Downstream Authority of the Quapaw Tribe of Oklahoma Regular Meeting
November 2, 2011

JCJ Review
Bill Dow/ Kristina Ennis

3 SOUTH ELEVATION
SCALE: N.T.S.

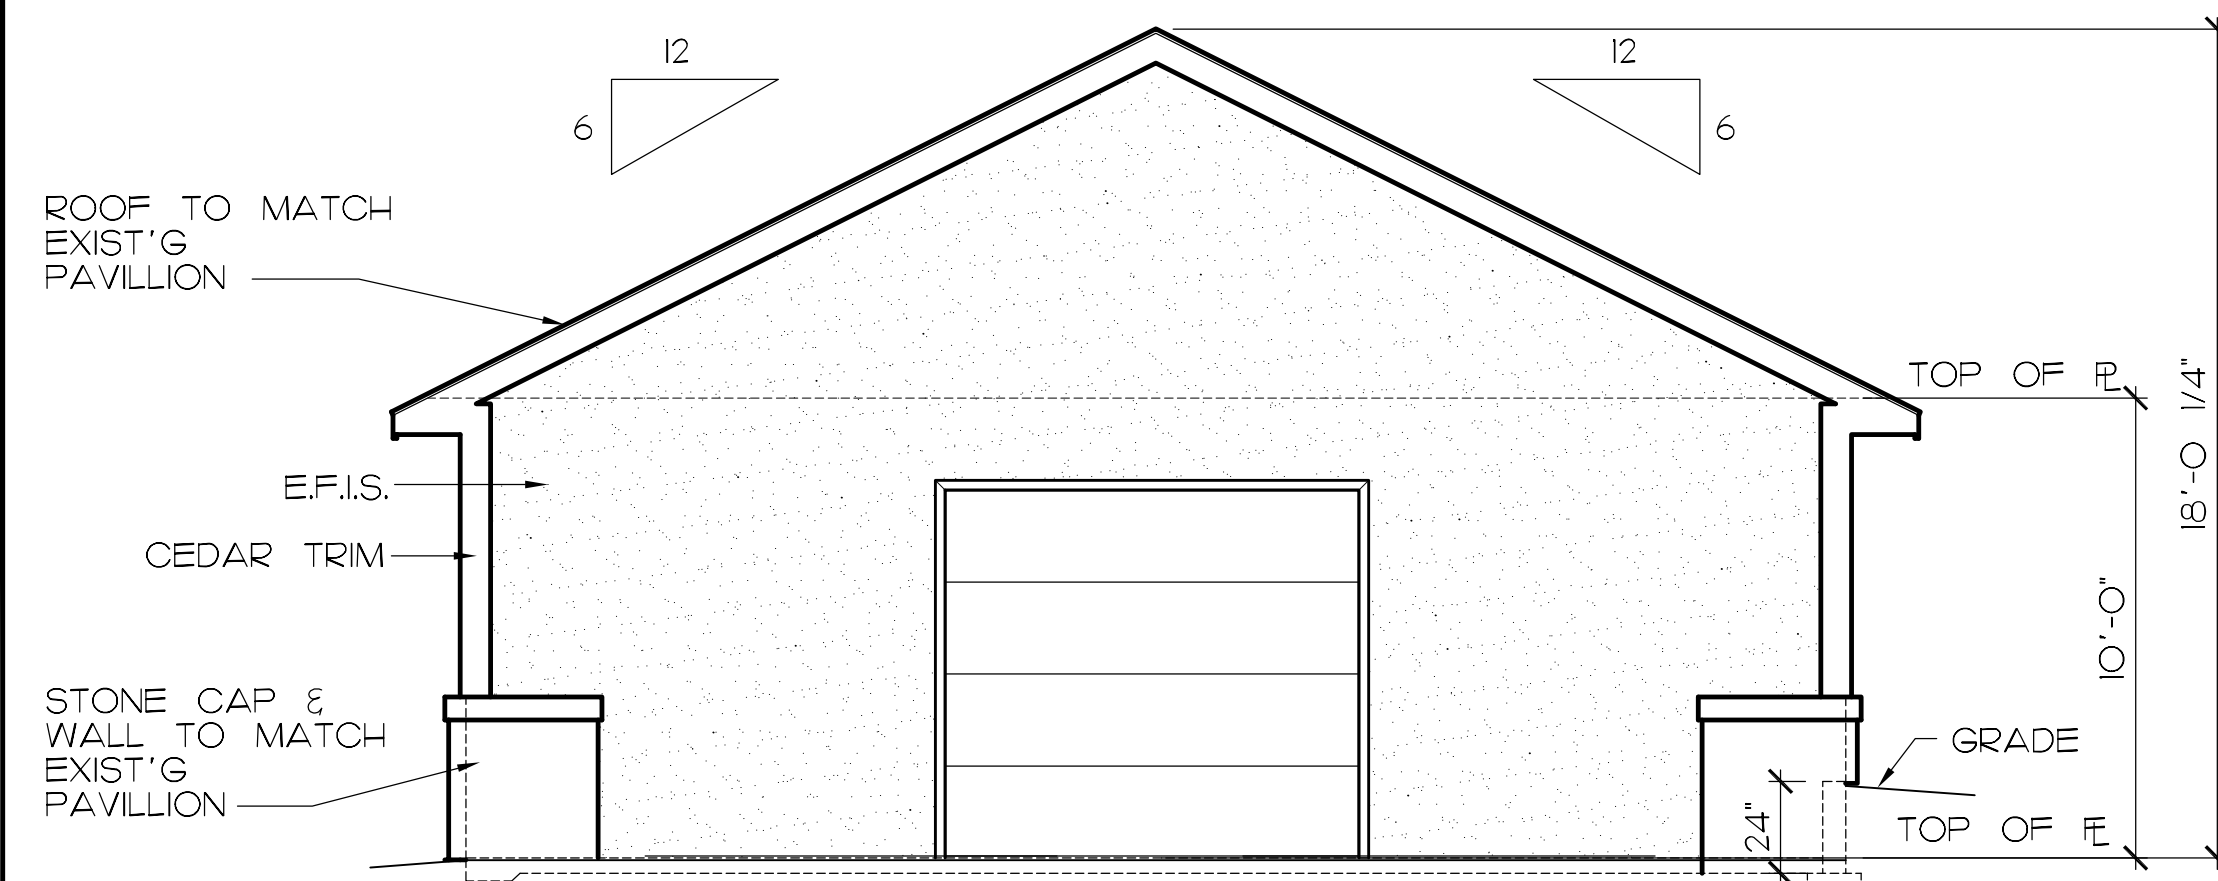
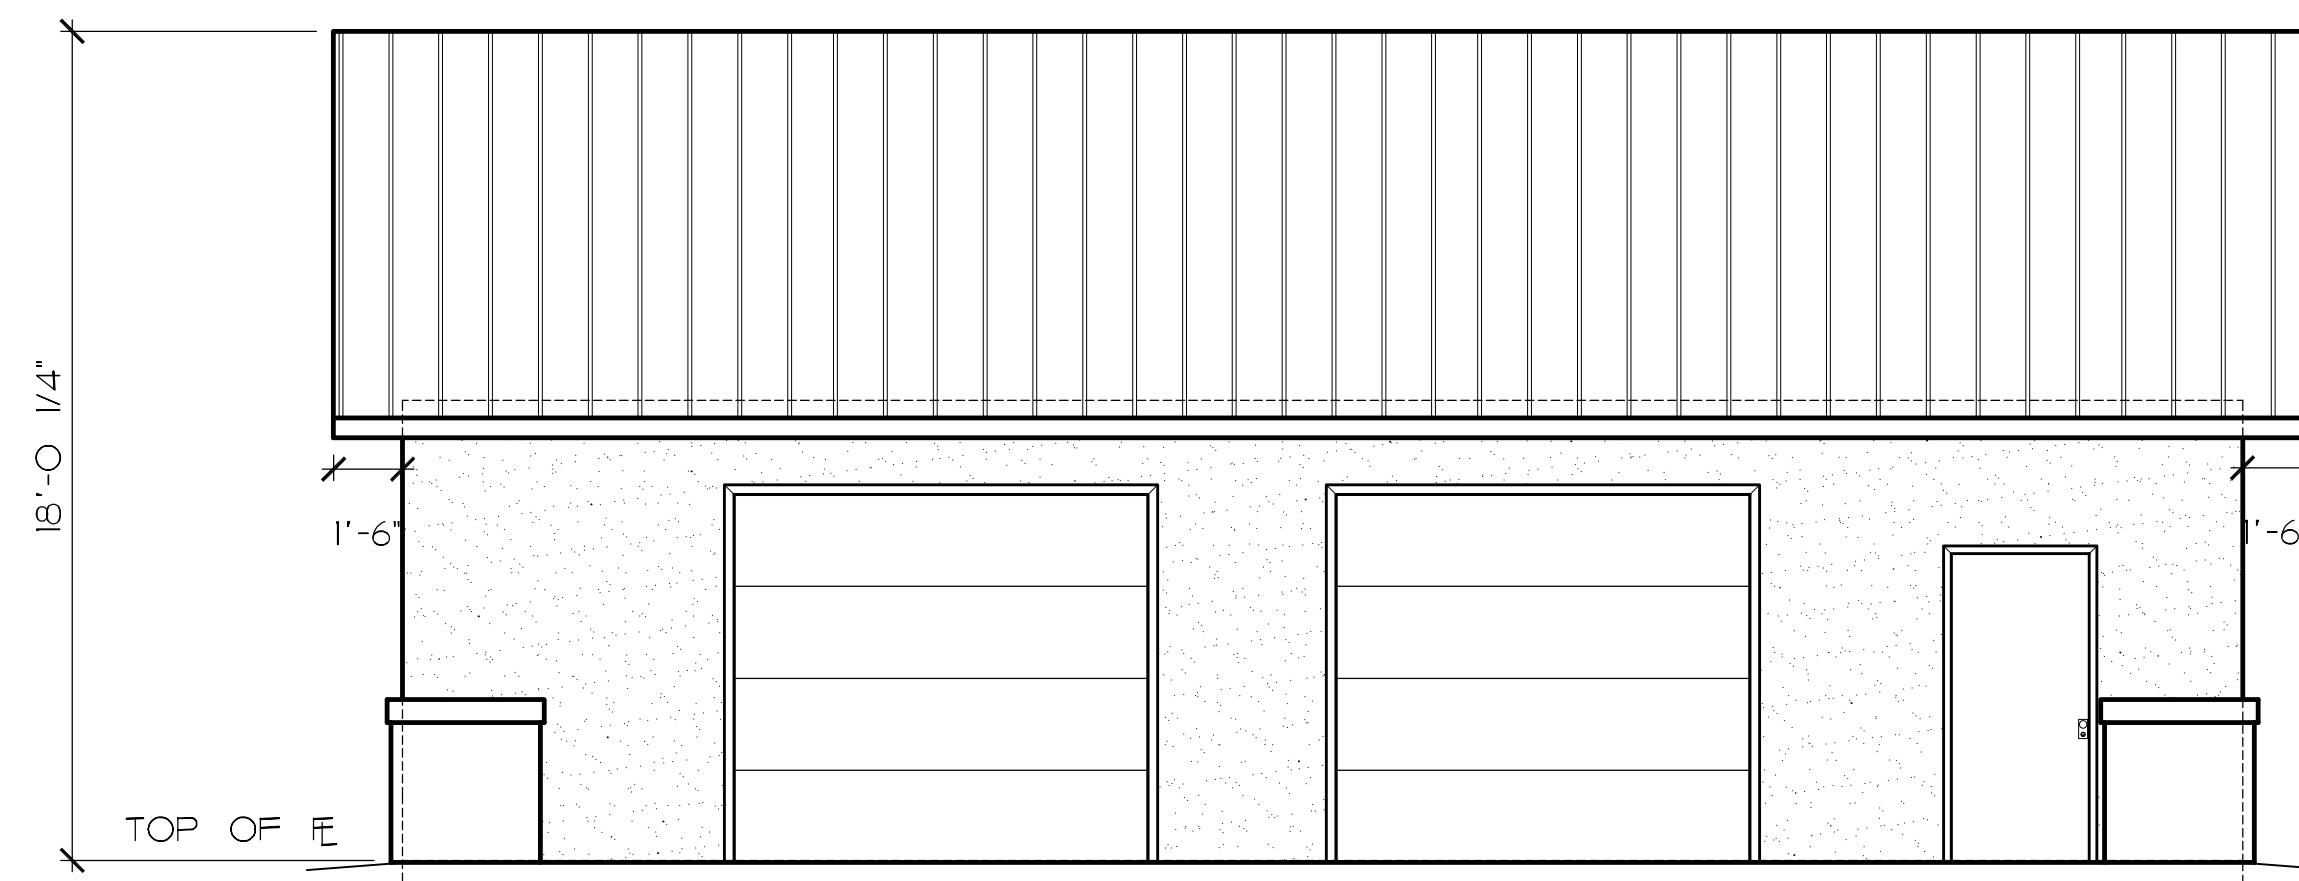
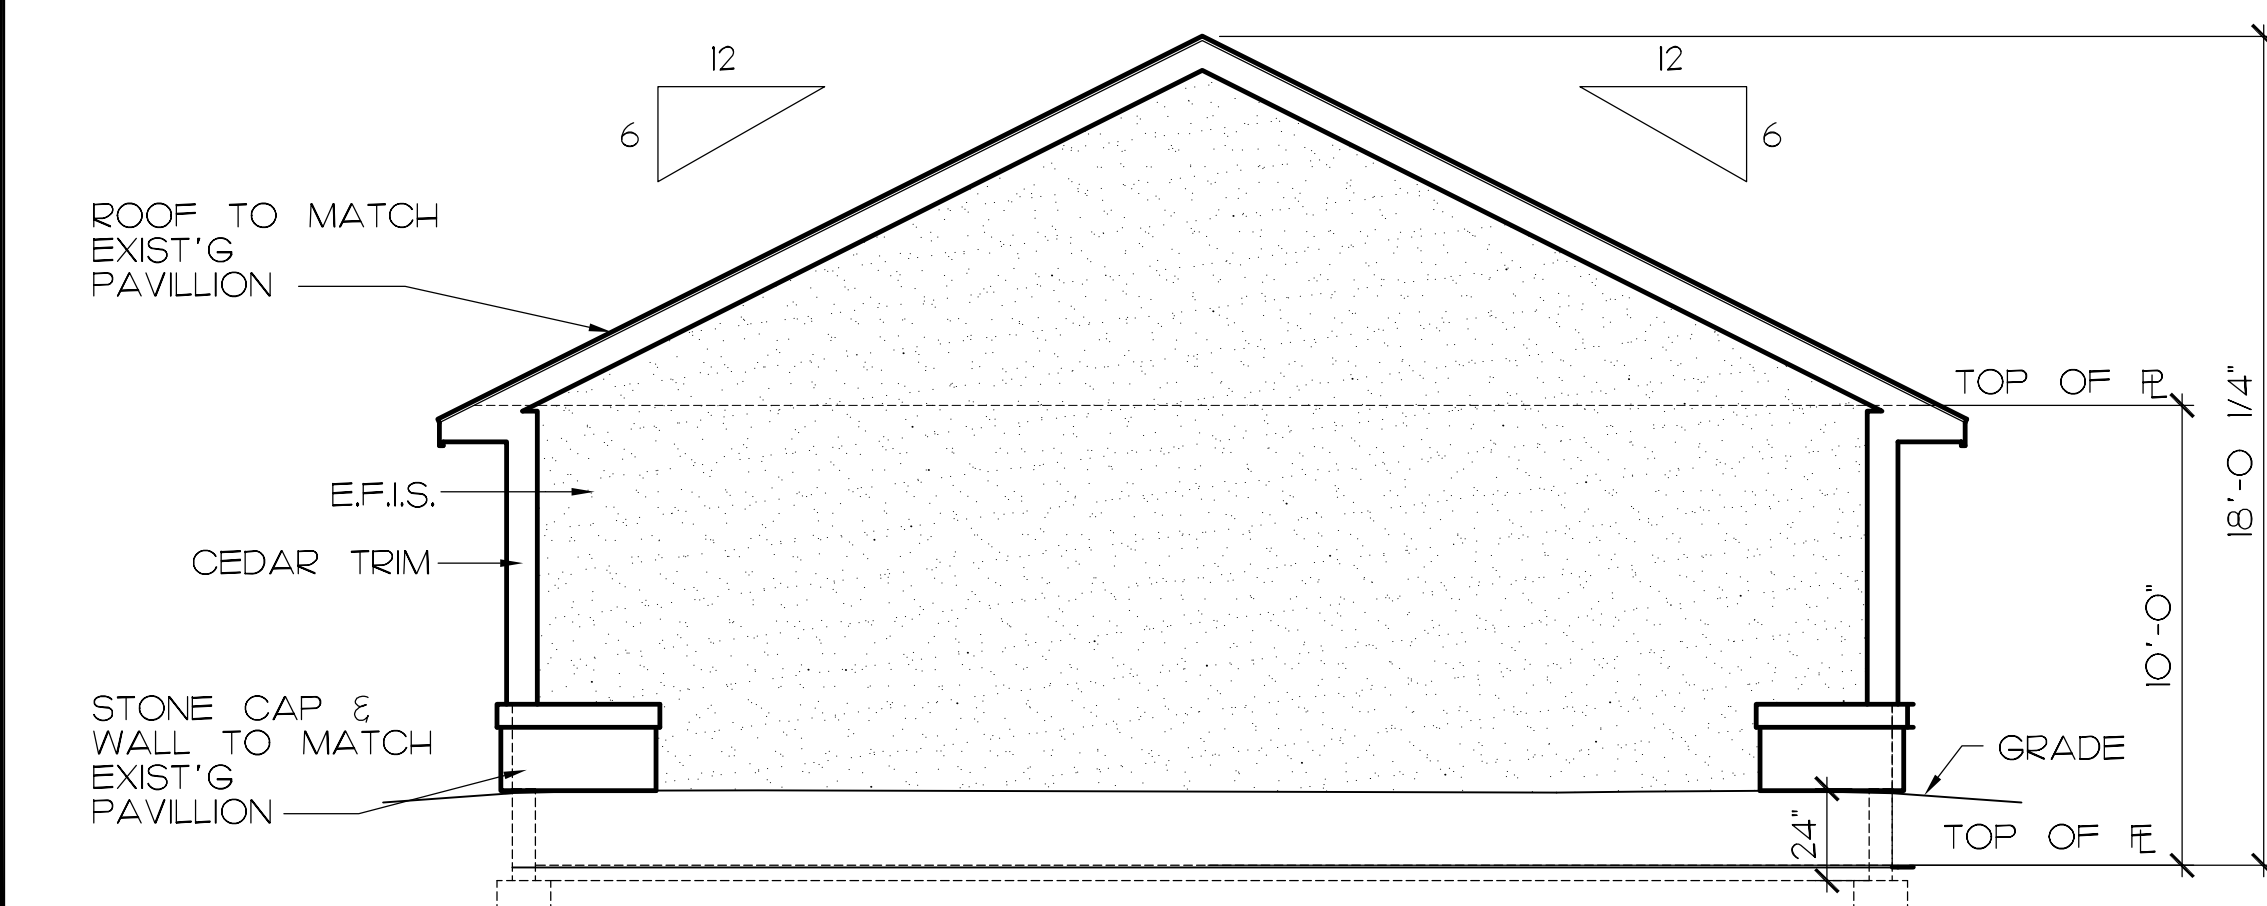
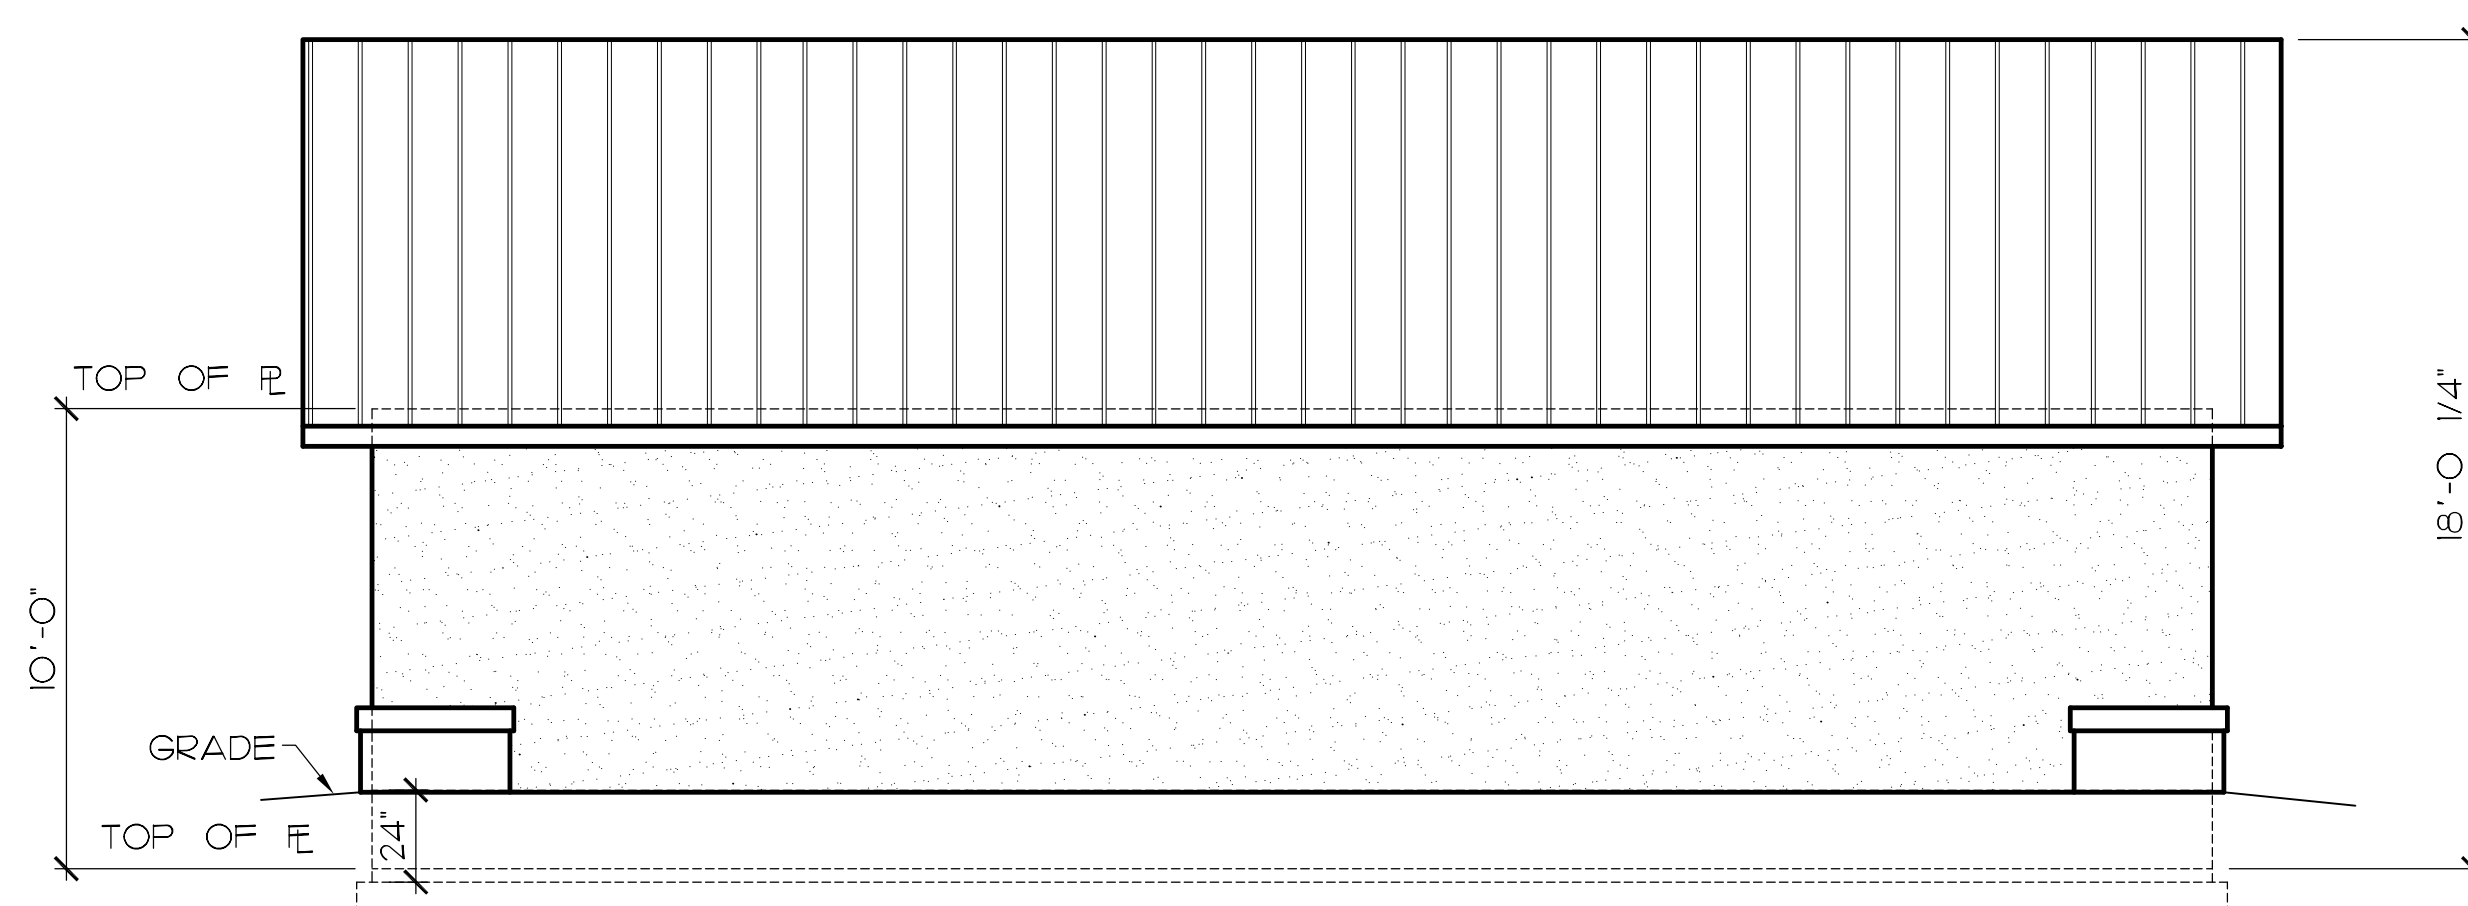
- o Review of building drawing that could be placed on grassy area beside/behind pavilion. Structure will be 30x40. Finishes will match pavilion: copper roof.
- o Doesn't need sprinkler. Building is 40' from corner of existing building. Can be stick frame.
- o Facilities can handle power.
- o Could use half for mock up and half for storage from the beginning. Ballpark # is pushing \$50K. Sticky stone or wainscot? 1 – 16' door vs. 2 – 8'.
- o Would like to move forward and have this built to be able to use before December. It is determined to move forward at least in pricing.
- o Chris Roper to have pricing for Mock up by end of this week.
